AMENDMENT TO THE DRAWINGS

ALIGNING FLASHLIGHT LAMP BULBS
INV: A. MAGLICA
DKT: 728256-100/119
REPLACEMENT SHEET

Fig. 3

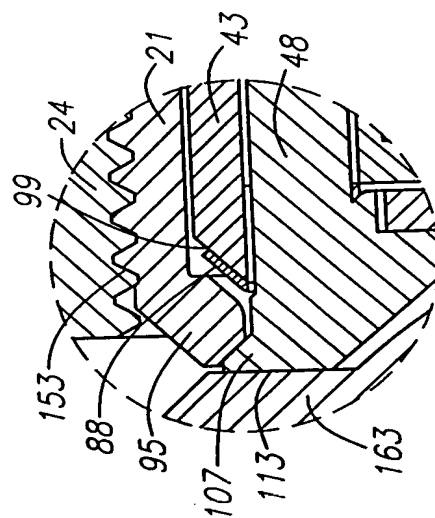
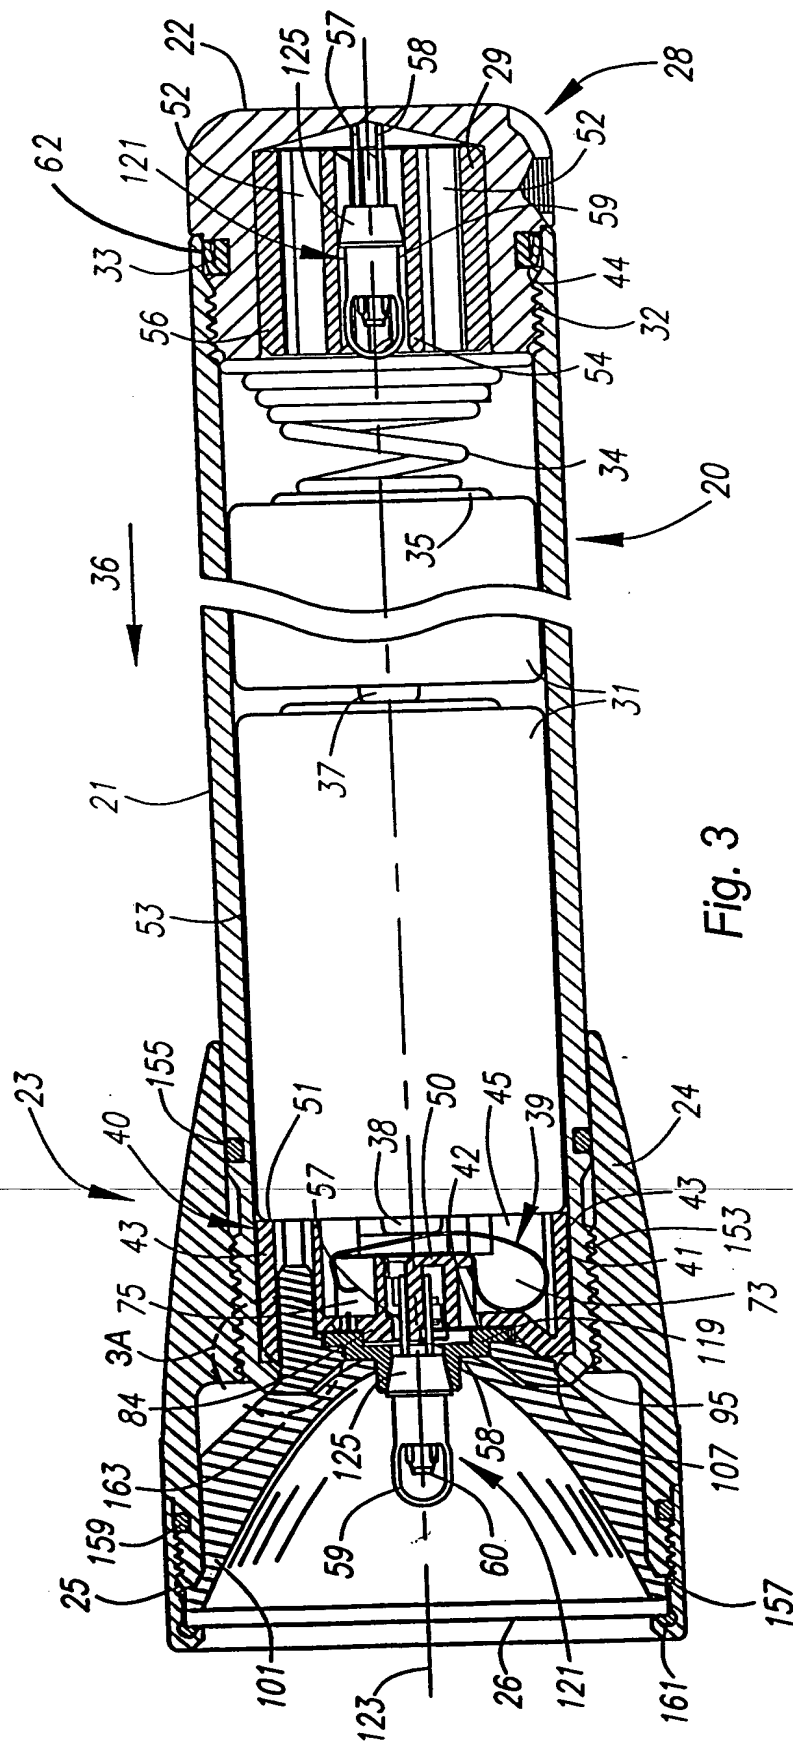
Replacement sheets 02/06, 03/06 and 04/06 replaces original sheets of drawings having the same sheet number. In each of amended Figs. 3, 5 and 6, a new element number character 62 is added to identify the "one way valve" that is disclosed in the body of the specification. The support for this amendment can be found in the specification, for example, at paragraph numbers [0041]. Therefore, no new matter has been added.

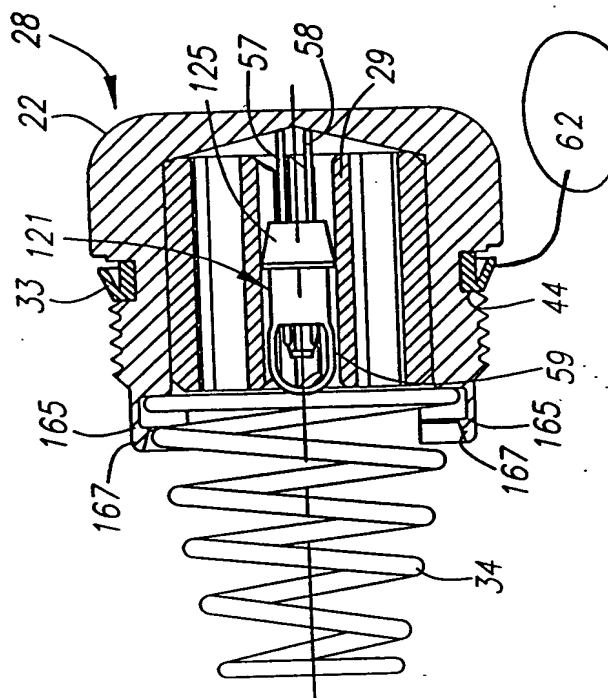
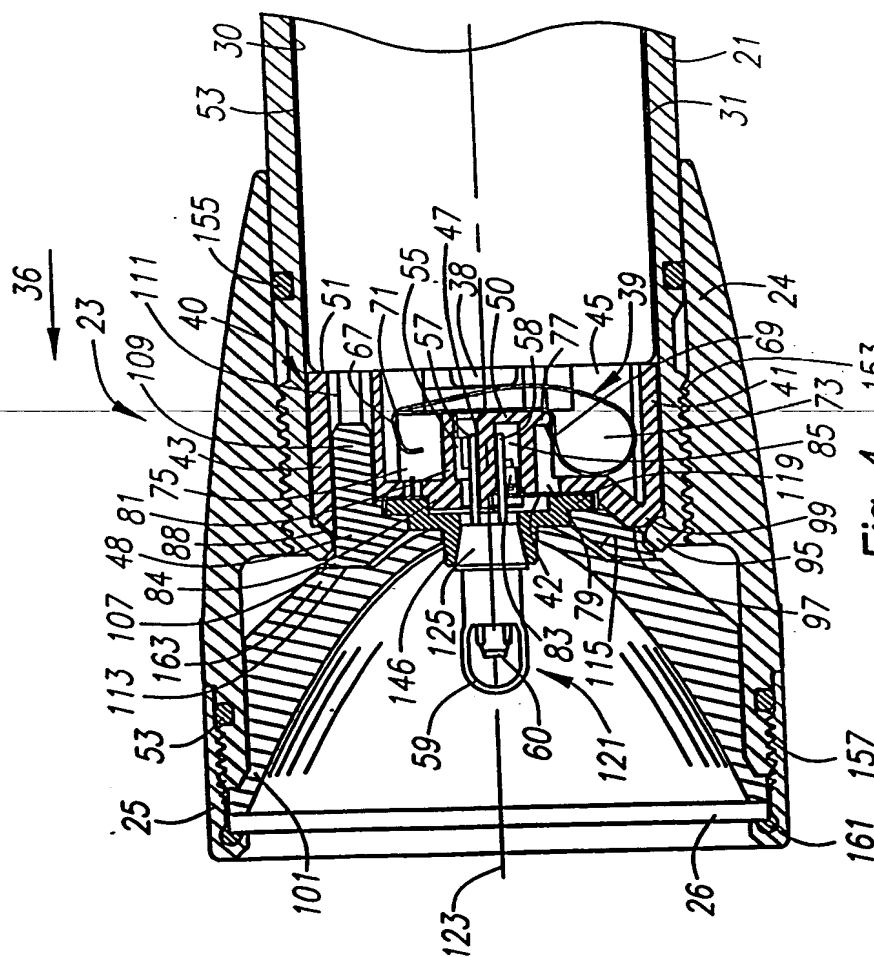
Element
62
address

2 Element 62 added

Fig. 6

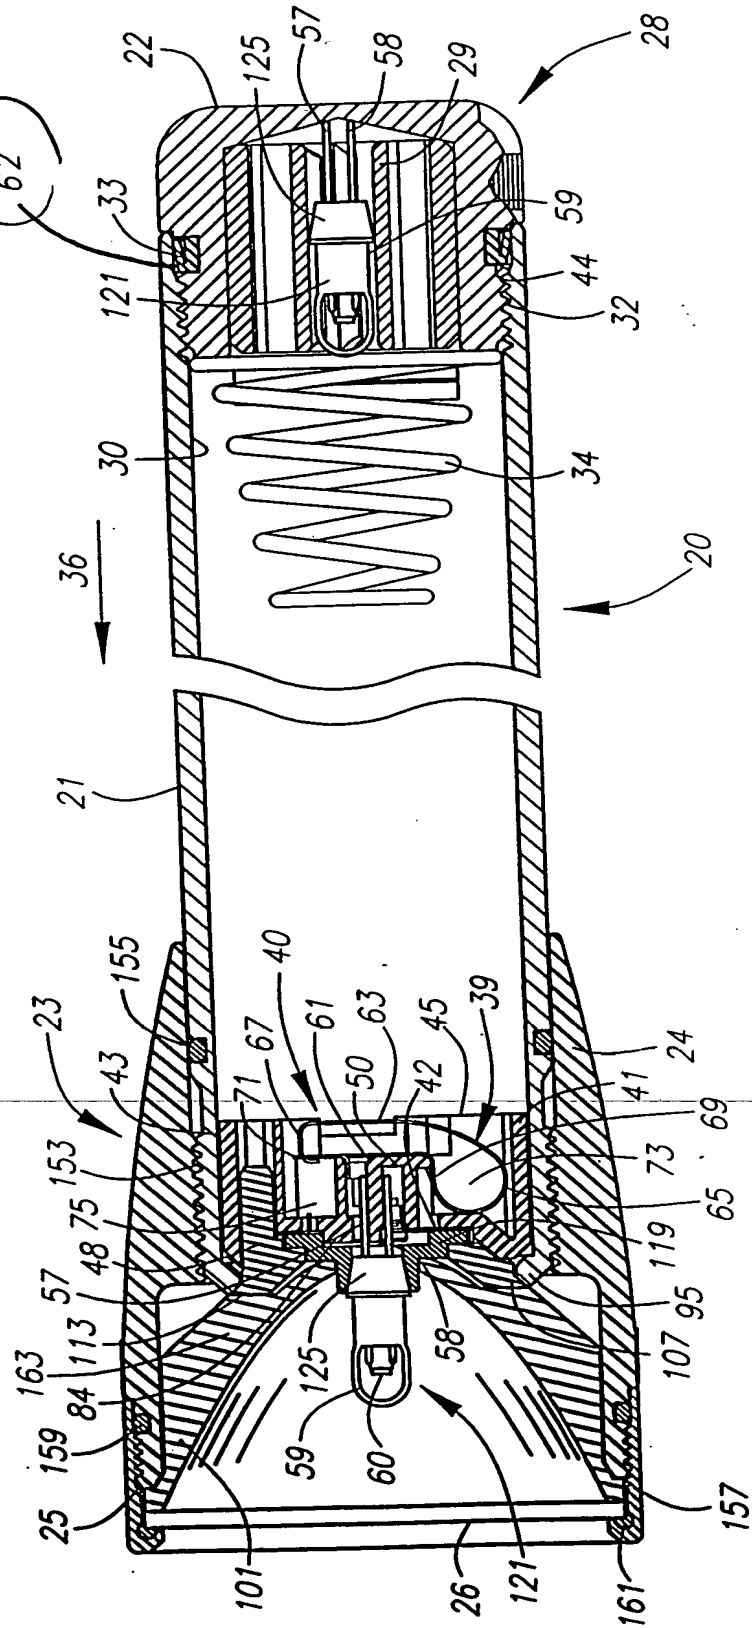
Element 62 added
